# Development Application **ACCESS REPORT**

**Reference Number:** 22334

**Client:** ZMP Architects

**Site Address:** 44 Cadaga Rd, Gateshead

**Ground floor plan**

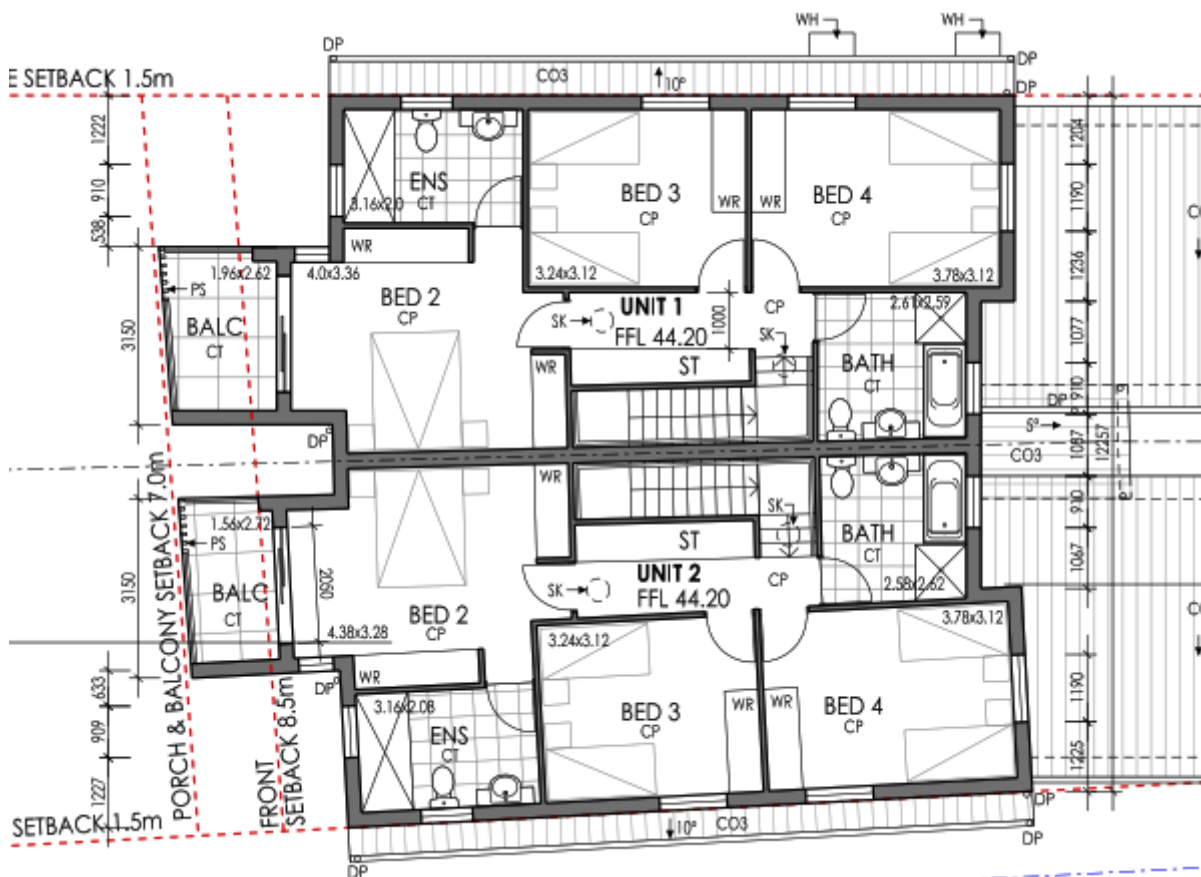
By incorporating the requirements of the below Checklist in the Specifications of the project, the nominated Duplex can achieve full compliance with Livable Housing Guidelines- Silver Level

All details to be verified at the CC stage
